A. General

On models 107 and 126 with 8-cylinder engine a new control unit with coding plug will be installed starting approx. 12.86. The 6-cylinder models will be phased in.

N4 Control unit cruise control/Tempomat without coding plug

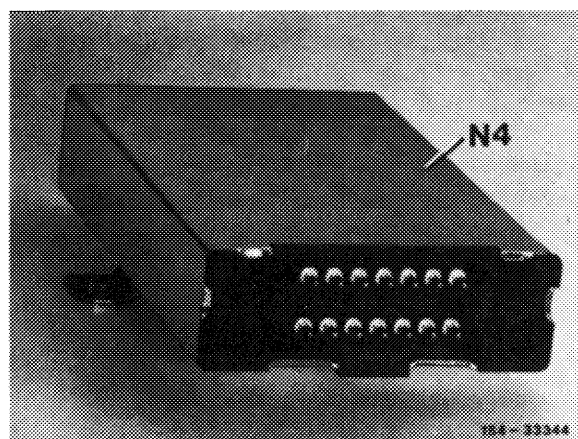
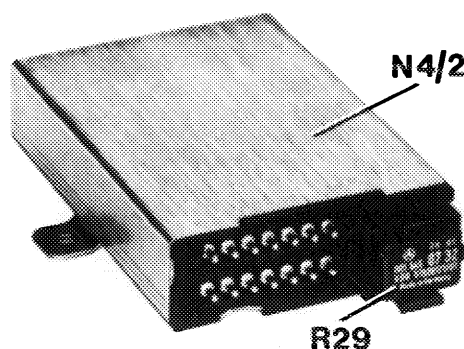
After using up spare parts stocks, only the new control unit and the respective coding plug will be available.

The new control unit with coding plug has no influence on cable lines and thereby also on wiring diagrams. Installation can proceed without changing harness.

N4/2 Control unit, cruise control/Tempomat
R 29 Coding plug, cruise control/Tempomat
